Norwest Marketown Planning Proposal

LPP Response Urban Design Package — 24/05/23

Local Planning Panel Advice

Figure 79. Illustrative Ground Floor Plan

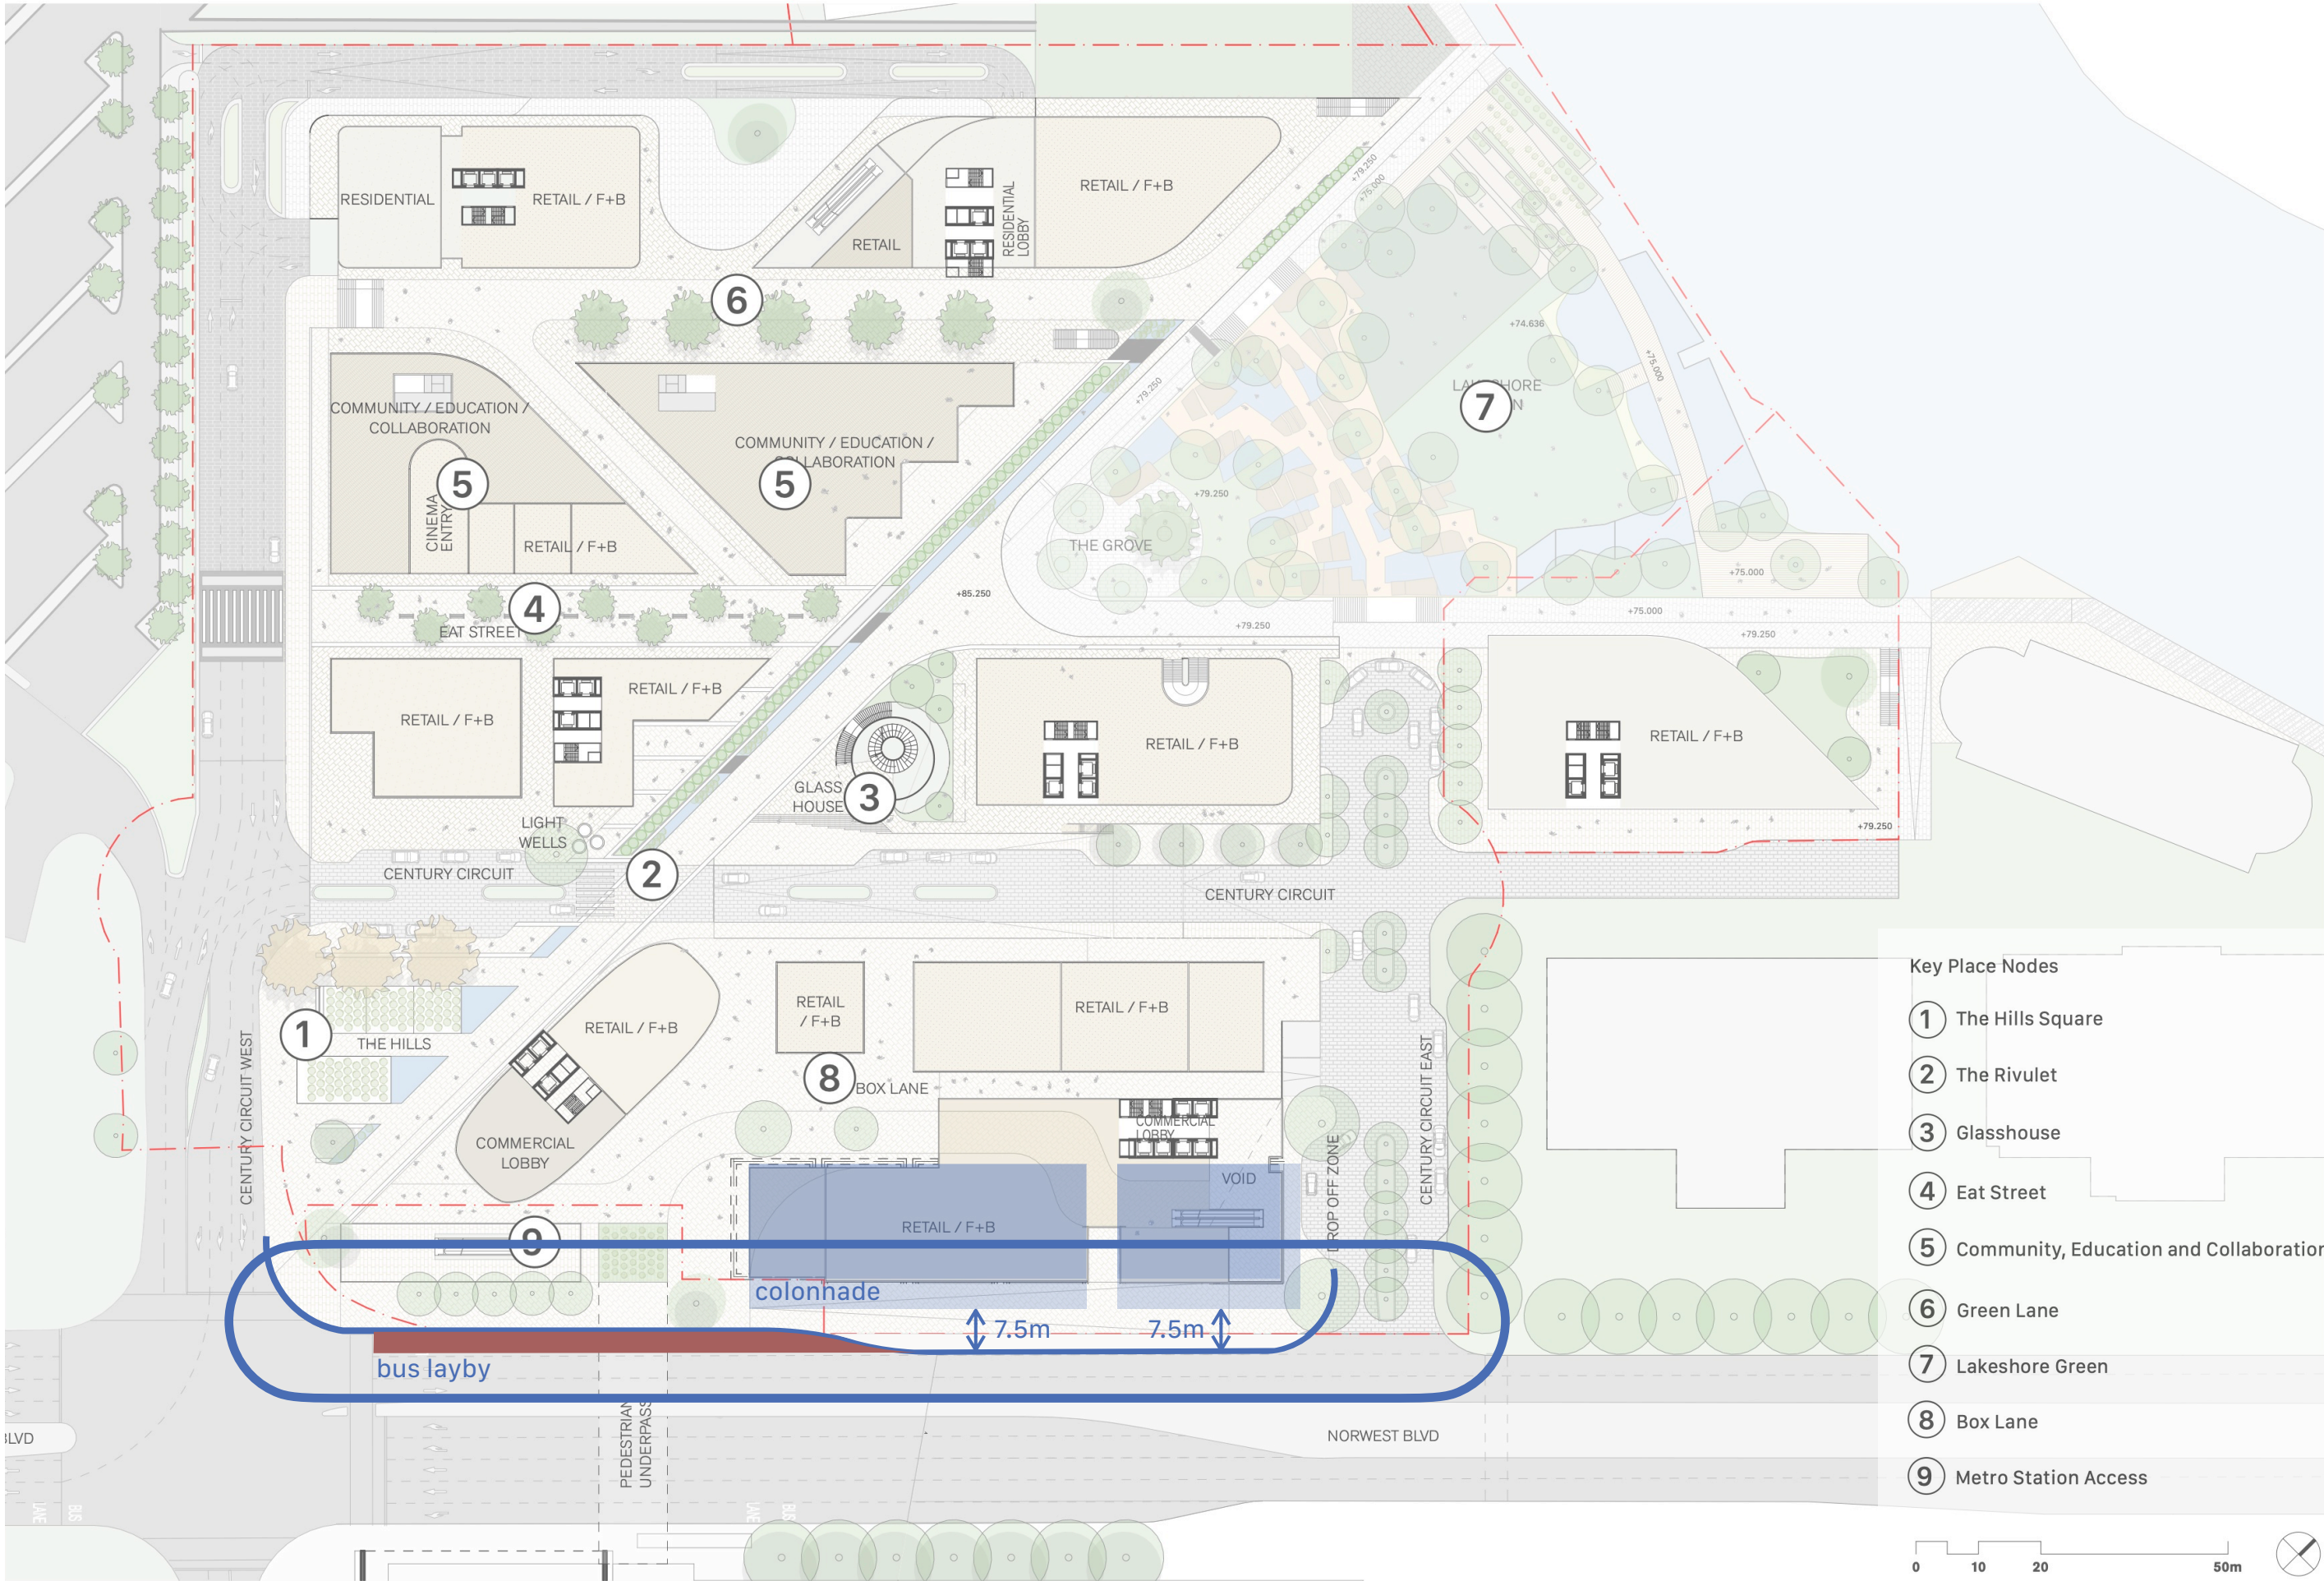
Improved landscaping and public domain treatments along the site's interface with Northwest Boulevard, which may potentially require increased setback distance;

The adjusted kerbline to align with the existing condition and landscape masterplan is indicated in the overlay on the indicative ground level plan.

In addition to the proposed colonnade, which provides sheltered access along the Northwest Boulevard frontage, a clear width of 7.5m is achieved from the proposed building line to the existing kerbline.

Figure 79. Illustrative Ground Floor Plan

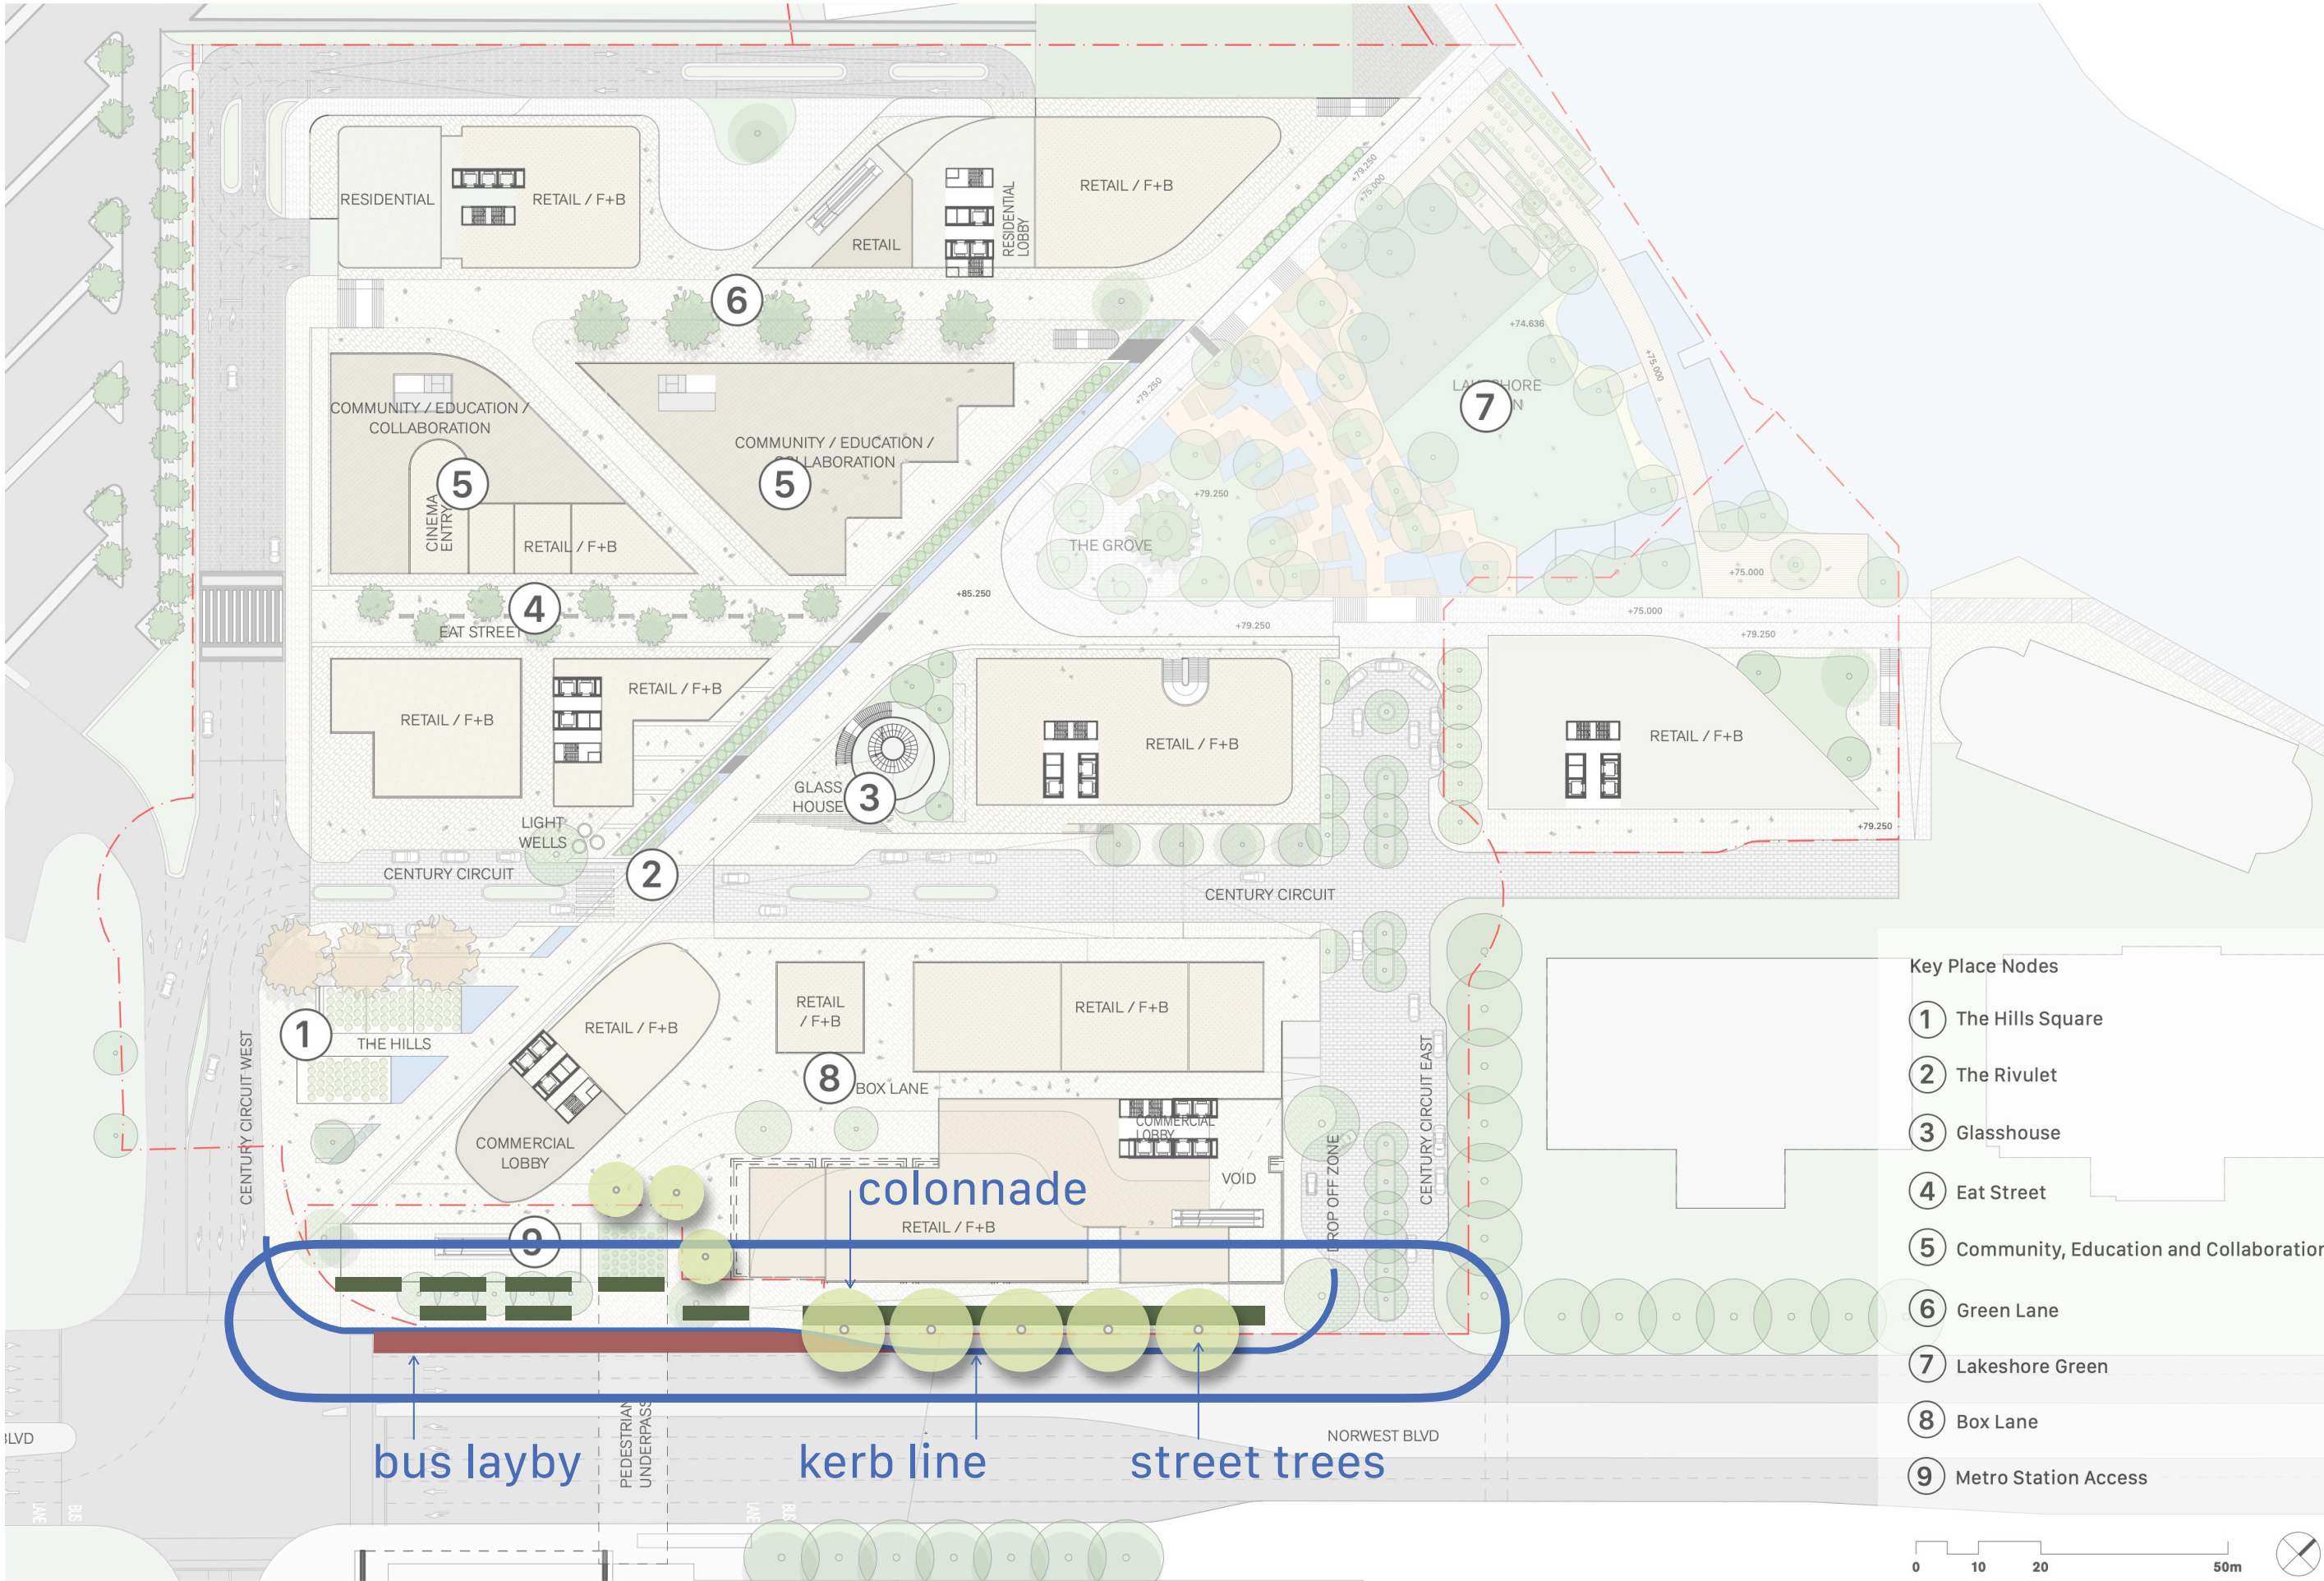
Improved landscaping and public domain treatments along the site's interface with Northwest Boulevard, which may potentially require increased setback distance;

The planting strips and street trees proposed in the landscape masterplan are accommodated between the existing kerb line and proposed building line.
